NIST NCSTAR 1-1A Federal Building and Fire Safety Investigation of the World Trade Center Disaster

Design and Construction of Structural Systems

(Appendices A-G)

Appendix A SUPPORTING DOCUMENTS FOR CHAPTER 2

OPERATING CHARACTERISTIC CURVE PROBABILITY OF ACCEPTING TAN 8 = 0.70 IS 0.05

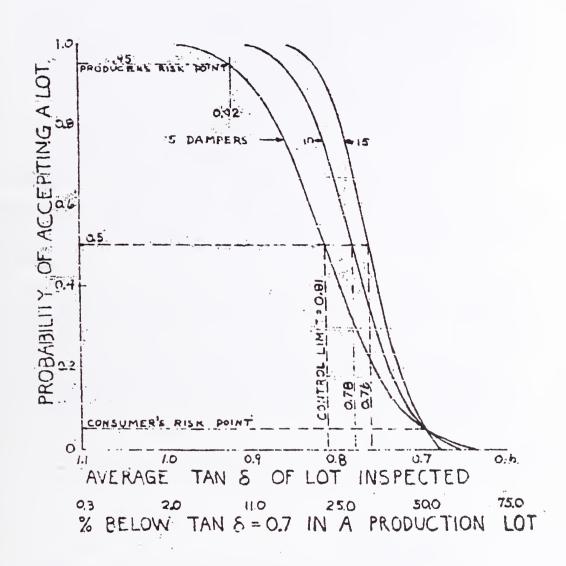
We are submitting the attached graph and explanatory remarks to illustrate the Acceptance Testing and Sampling Plan. Obviously a similar graph applies to stiffness, ultimate shear strength and fatigue resistance.

- The curve gives average values of lots that have been estimated from samples of five (chosen at random at a rate of one per day) per lot. We are using average values to describe the minimum quality you can receive in preference to values for single dampers because:

DEPTH, WIDTH AND OUT-OF-SOUARE TOLERANCES (BEAMS) SKILLING, HELLE, CHRISTIANSEN, ROBERTSON

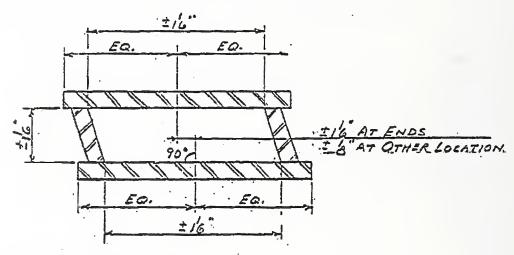
Fubrication tolerances as set forth in Specifications 304.100 and 305.100 are clear as far as built-up columns are concerned, however they are not clear as far as built-up box beams are concerned. We do not feel that it was ever intended for the box beams, which are considerably lighter than the box columns, to be fabricated according to tolerances shown on sheet 3-04 which partoins to box columns.

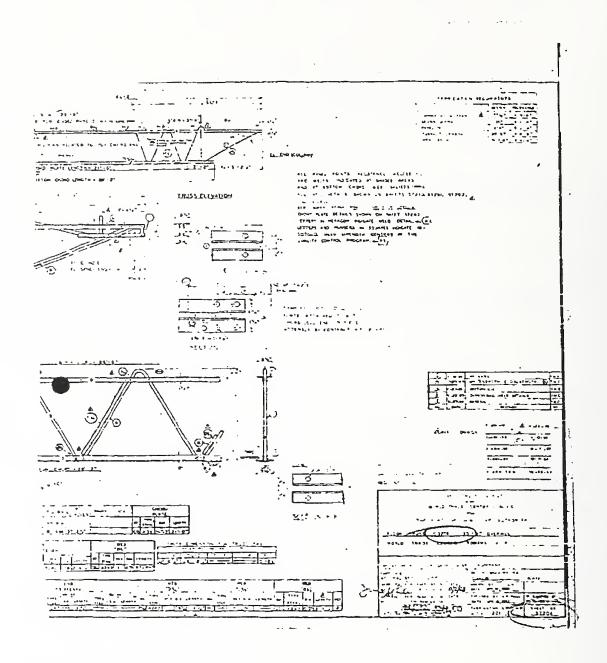
This letter is written to request a tolerance of $\pm 3/8"$ for the dimension of 2-7/8" or 1-3/4" that locates the upper end of the Inclined Strut (Mark 2) which is fabricated in one or both ends of the following 24" trusses.

2479	24711
24T9A	24T11A
24T10	24TllB
Shijov	247113
24T10B	24T12
247100	24713
24T1OD	24T13A
24T19E	24T13C
24112	24T13D
24T10H	BT215A
24T10J	BT216B
24T1 0%	310100
2002

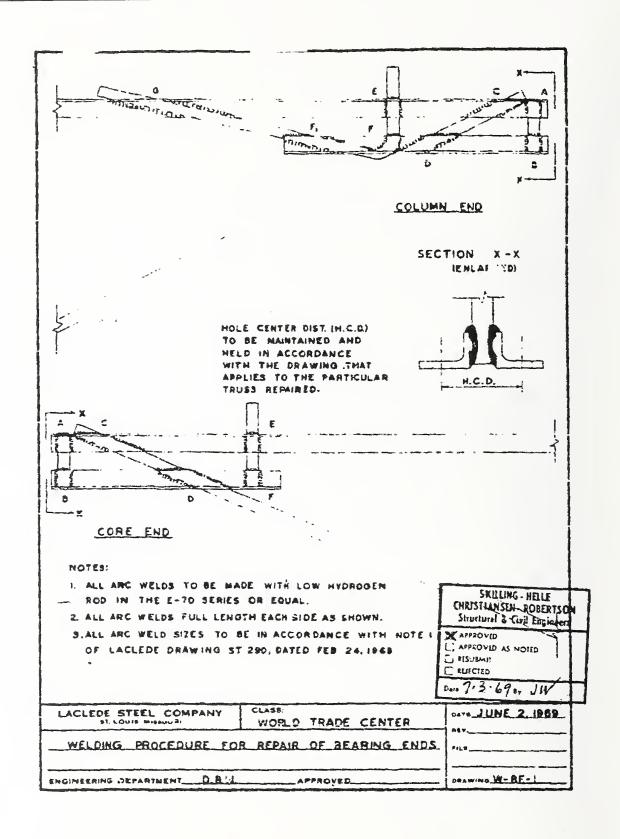
Under the supervision of the Certified Arc Welder Foresan, a Certified Arc Weld'r will perform the necessary repairs. The lettered joint to be repaired will be burned apart with a torch. All wold splatter from the previous resistance weld will be removed from the surface to be removed so that there is a clean surface of base metal. (If the wold is already separated, burning yours to be required but removed of the weld splatter material must be accomplished.)

With reference to the drawing N-DE-1 of the particular lettered joint to be welded, the members will be accurately positioned and the watering of the joint will be traplaned in accordance with the existing procedures for are welding which have been previously approved. The discussions of the welds which are full-length shall be in accordance with the table on drawing ST290 dated Fabruary 26, 1911.

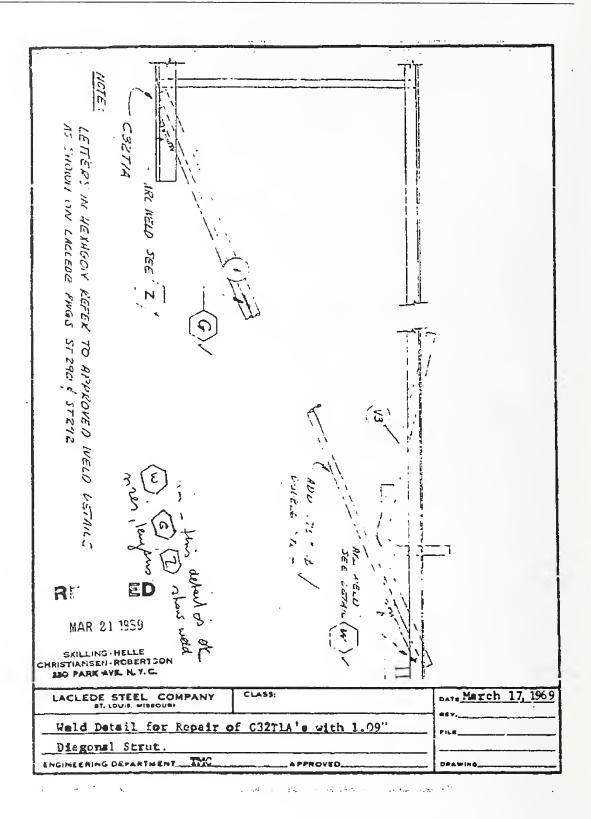
The 24 C32TlA Trusses have been fabricated at our Madison Plant with the V3 and diagonal strut on the column end with 1.09" web stock instead of 1.14" as shown on the approved drawing.

We request that the trusses be approved after repairing them by double strutting the diagonal strut with a .75 bar as shown on the attached drawing.

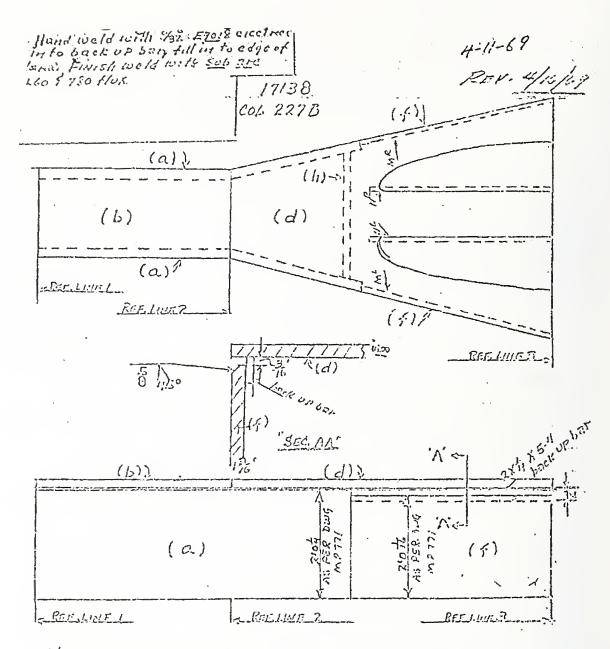
Egg crose poblicated & too wide on one corner,
in fitting (\$) Br. to egg crote, ca bottom side in as beld flush,
leaving & botween top of egg crote and fop of Rr. f

Request permission to use back up bor, to fill void, CA
between f and cover plata d.

Verbal approval recieved from H. Fish 11.10-19 to make up difference in width of Plates fit a by using 2xti. back up bars, facked to fi Plate, Written approval to follow R. Swant O.C.
